Report: TAB Report
Function: Test, Adjust, & Balance
Date: 09/23/2025
Completed By: National TAB

06-09-25 WAWA #6305 WAYCROSS, GA

Project: 06-09-25 WAWA #6305 WAYCROSS, GA

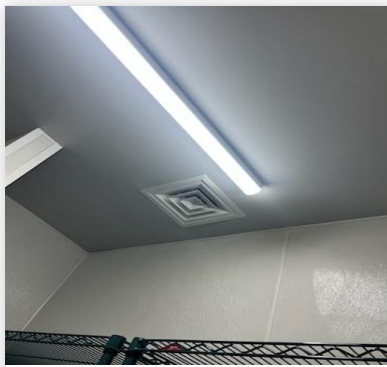
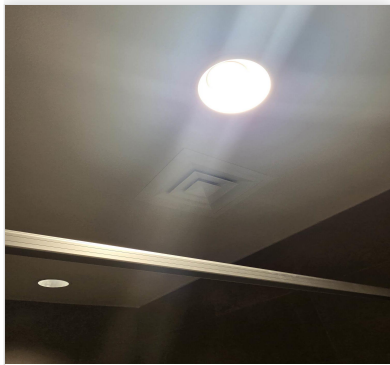
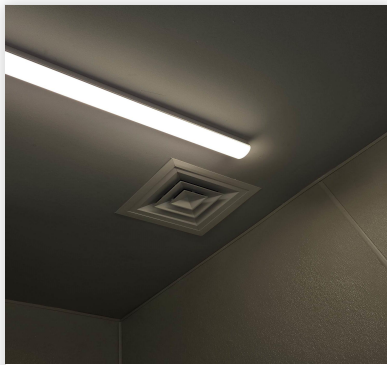
Issue Name : EF1-1and EF4-4 have wrong diffuser type installed
Description : Currently installed are CD-4 supply diffusers when GRD calls for G-3 exhaust diffusers.
Created By : National TAB **Assigned To :** National TAB - Will Turnbough
Status : Open
Priority : Urgent **Asset Tag :**
Originated Date : 06/10/2025 - Ian Fuller - National TAB

- **11/07/2025 National TAB - Stephen Tassinaro**
 - Supply type diffusers still installed on exhaust.

-
- **09/23/2025 National TAB - Stephen Tassinaro**
 - Unresolved 9/22.
-
- **06/30/2025 National TAB - Ian Fuller**
 - Issue not resolved as of 6/30. Supply type diffusers still installed.

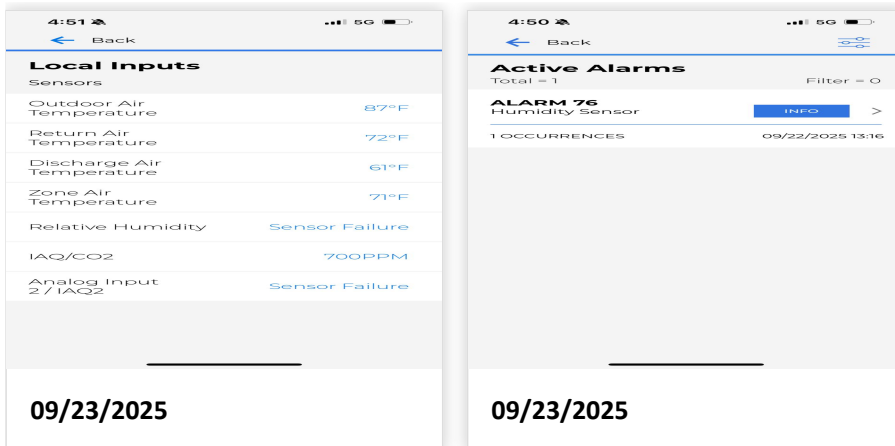
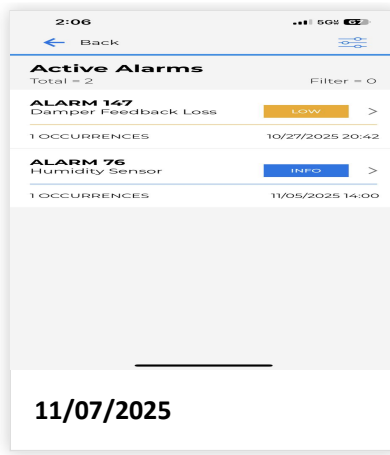
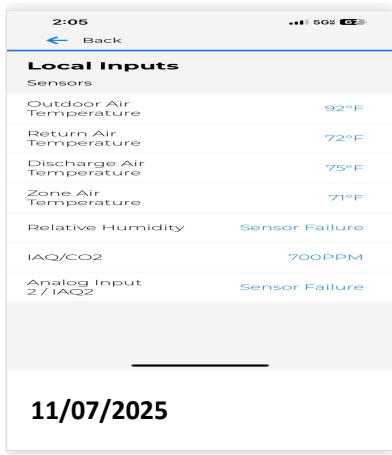
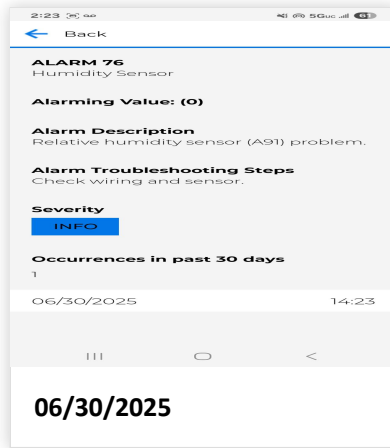
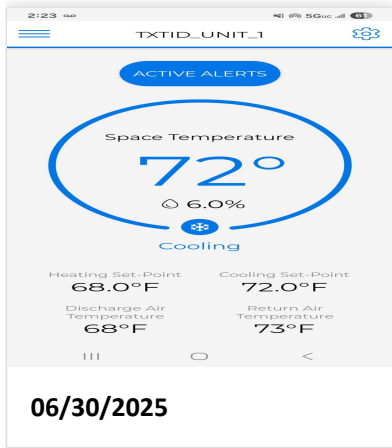
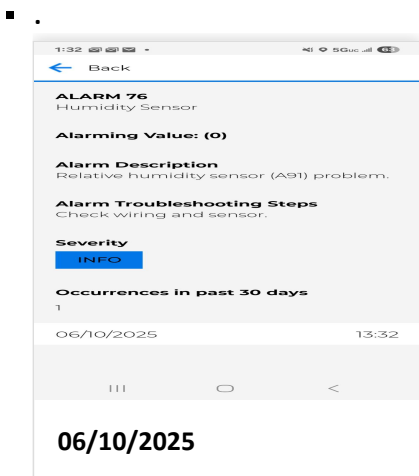
Issue Name : RTU-1 humidity sensor
Description : Humidity sensor is not reading correct humidity. Sensor starts to read at 8% then jumps to around 35% when humidity in the building is around 53 % RH. Humidity sensor wiring is per spec. **VERIFY ALL THREE UNITS ARE READING A REALISTIC RELATIVE HUMIDITY IN ORDER TO CLOSE ISSUE.**

- **11/07/2025 National TAB - Stephen Tassinaro**
 - Sensor still reading between 8% and then sensor failure. Likely a short in the wiring or terminals landed incorrectly.

- **09/23/2025 National TAB - Stephen Tassinaro**
 - RTU-1 is still alarming for humidity sensor. Unresolved.

- **06/30/2025 National TAB - Ian Fuller**
 - Issue nit resolved as of 6/30. Core alarm is still present on system.

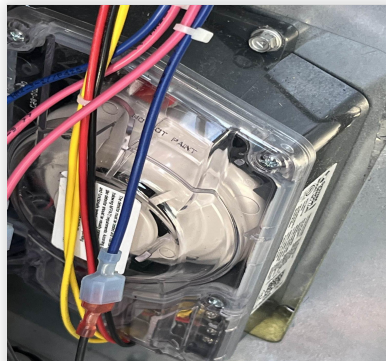
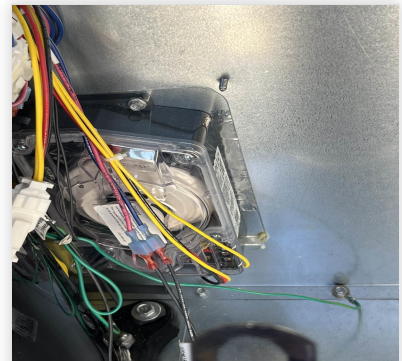
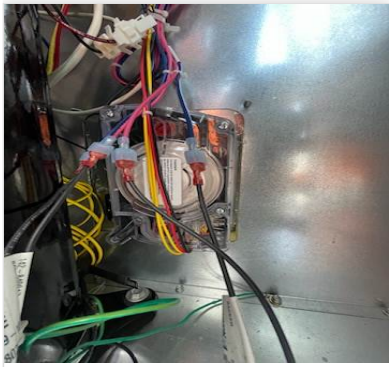
Issue Name : Smoke detector dust plugs are still in unit
Description : Recommended to remove dust plugs in all units before store operation.
Created By : National TAB **Assigned To :** National TAB - Will Turnbough
Status : Open
Priority : Medium **Asset Tag :**
Originated Date : 06/10/2025 - Ian Fuller - National TAB

- **11/07/2025 National TAB - Stephen Tassinaro**
 - Dust plugs still installed on return side smoke detector heads.

-
- **09/23/2025 National TAB - Stephen Tassinaro**
 - Unresolved 9/22.
-
- **06/30/2025 National TAB - Ian Fuller**
 - Issue not resolved as of 6/30.

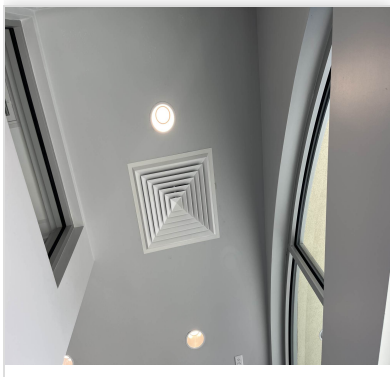
Issue Name : Transfer duct in vestibule has wrong diffuser installed.
Description : A supply type CD-2 diffuser is installed when the GRD specifies a return type G-2 diffuser is installed. The correct diffuser type needs to be installed.
Created By : National TAB **Assigned To :** National TAB - Will Turnbough
Status : Open
Priority : Medium **Asset Tag :**
Originated Date : 06/30/2025 - Ian Fuller - National TAB

- **11/07/2025 National TAB - Stephen Tassinaro**
 - Supply type diffuser still installed on vestibule transfer grille.

- Unresolved 9/22.
